Release Note for AIC SAS 6G 2U24-2 Expander

Oct 31, 2018

Changelog

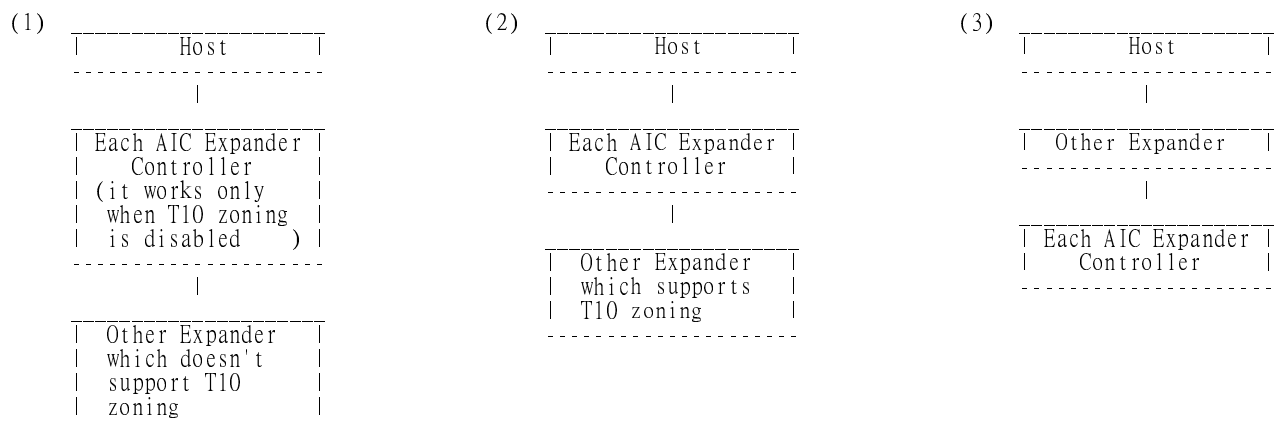
6. The order of drive slot id is changed. The order in firmware 0.6.x.x is from top to bottom, then from left to right, and the first slot id (the top-left drive) in SES page is 0. The order in firmware 1.11.1.1 is from left to right, then from top to bottom, and the first slot id (the

top-left drive) in SES page is 1.
